THE SHOP'S AT MERIDIAN RANCH

FILING NO. 1, LOT 4
LANDSCAPE PLAN
EL PASO COUNTY, COLORADO.
FALCON, COLORADO

DRAWING NO. 2
LANDSCAPE PLAN

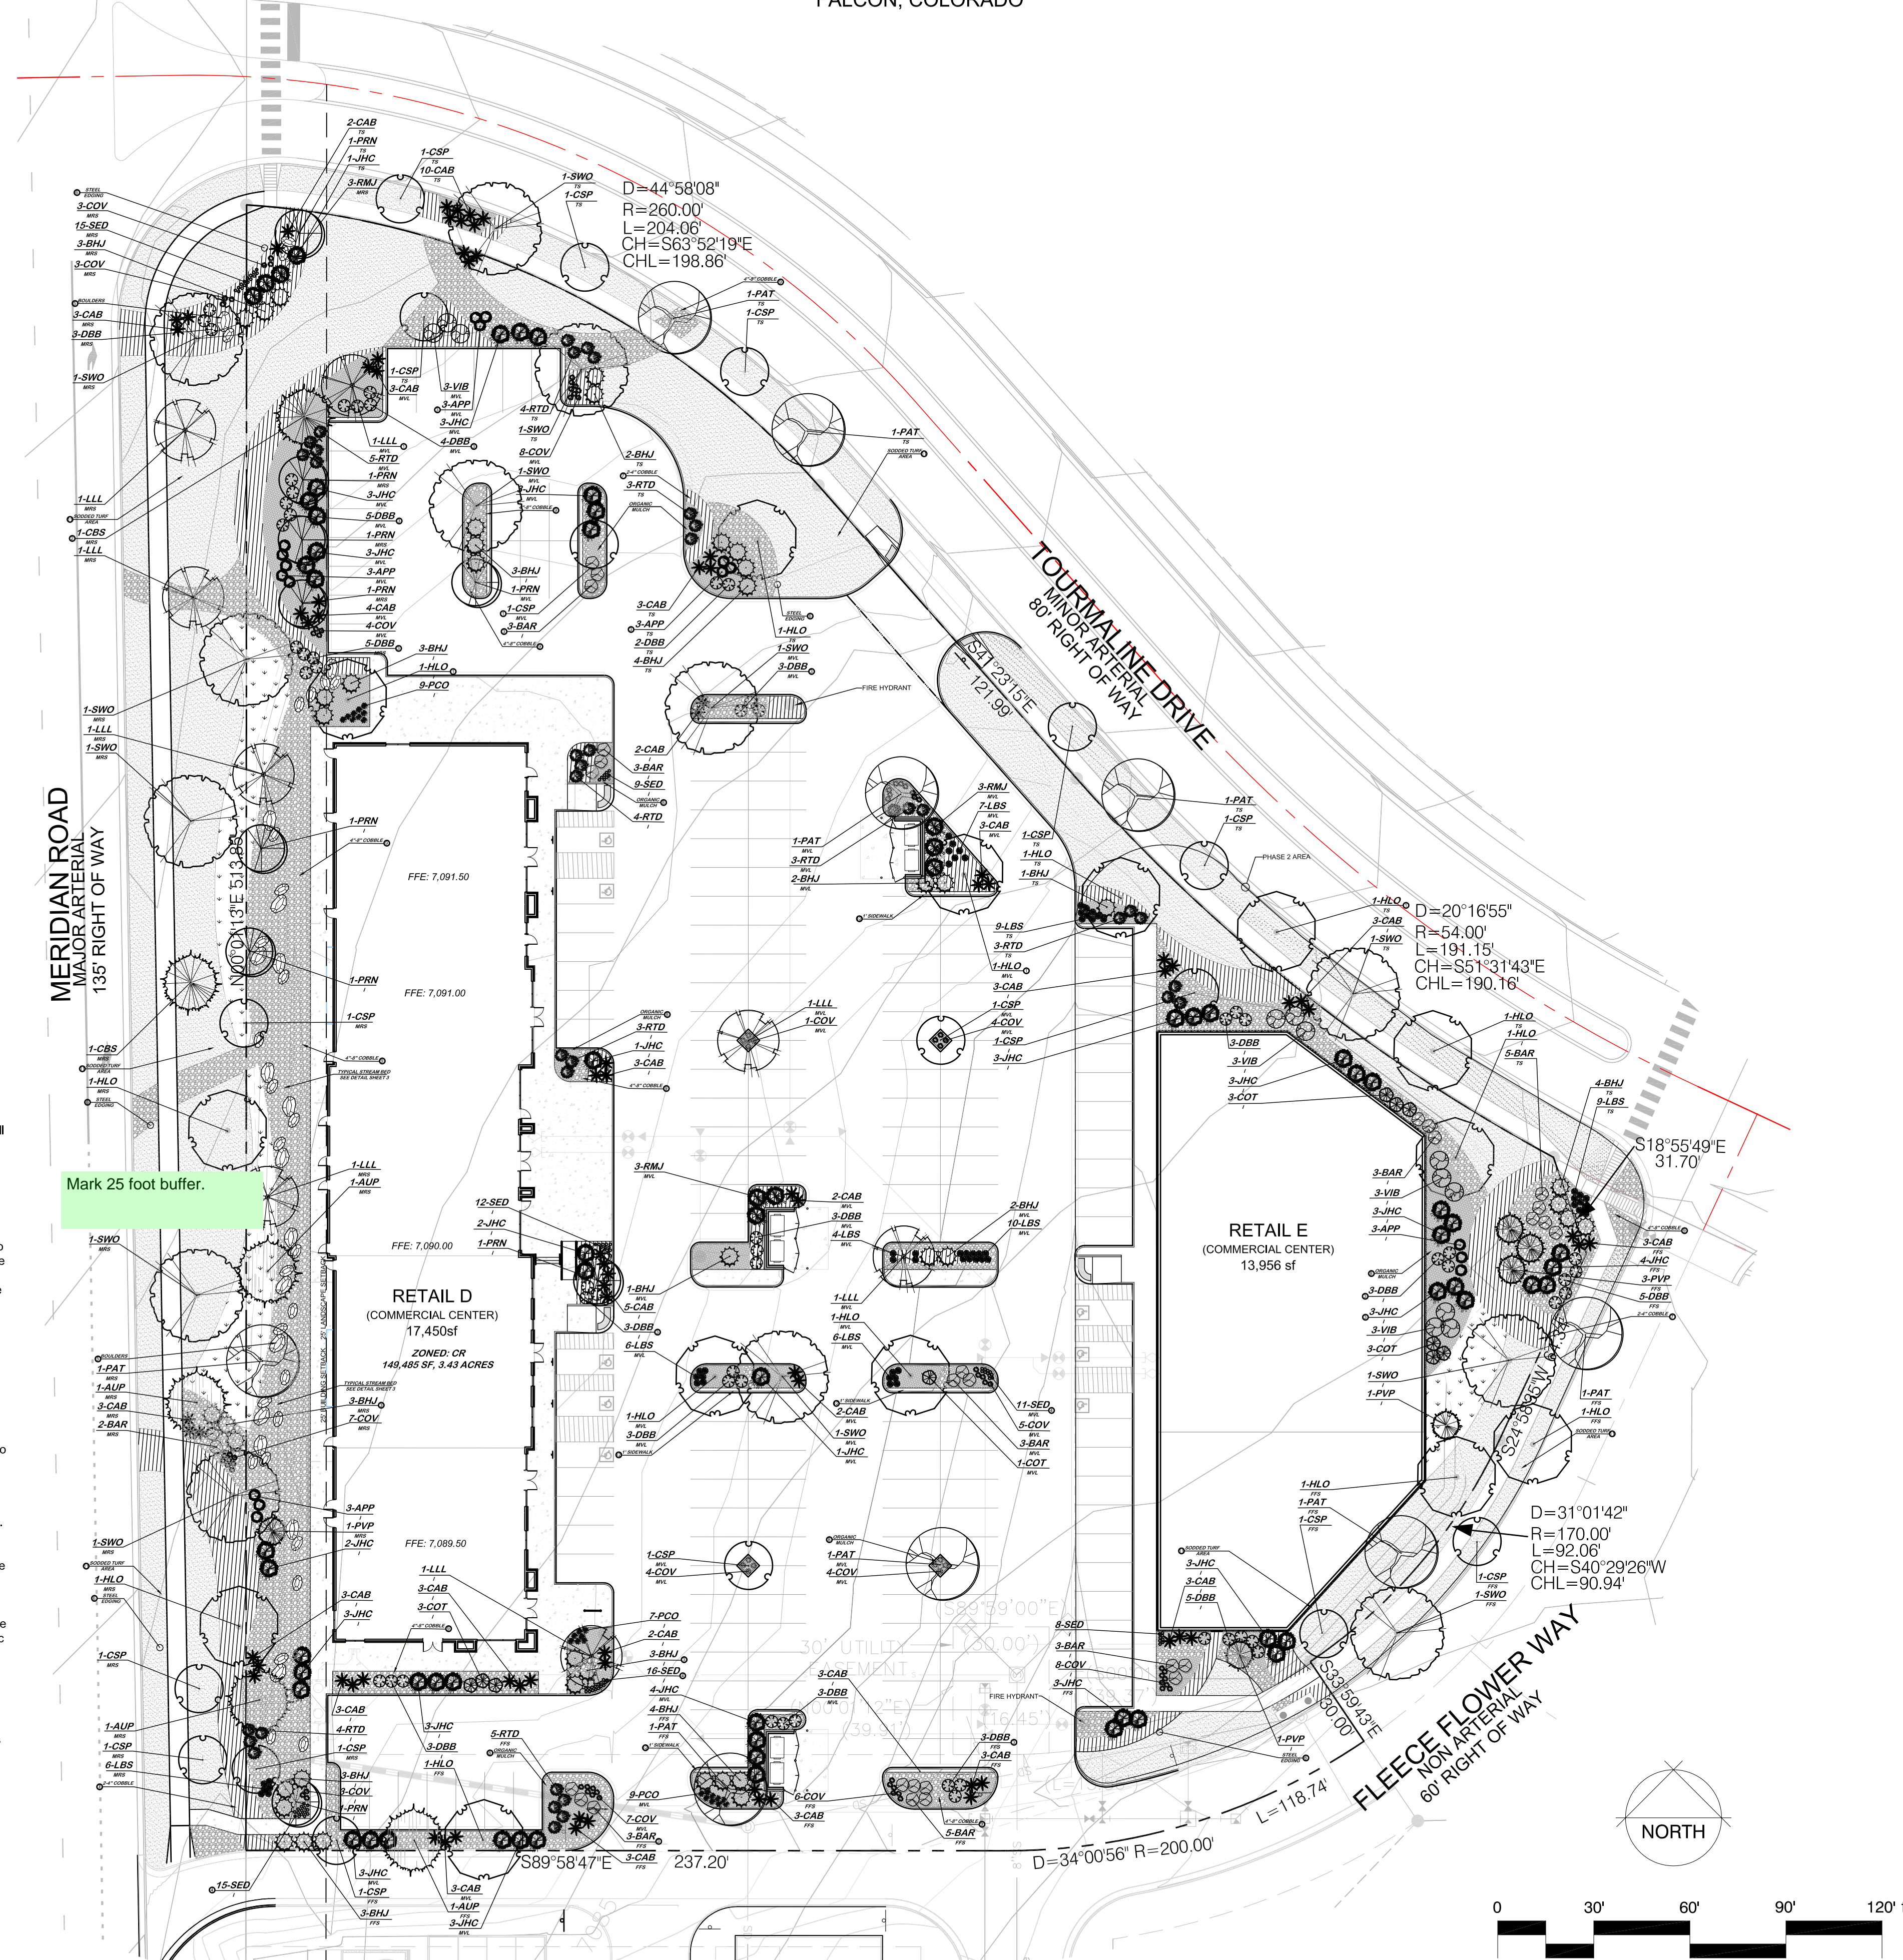
Show how you are going to meet these requirements. Are the shrubs replacing trees?

Mark 25 foot buffer.
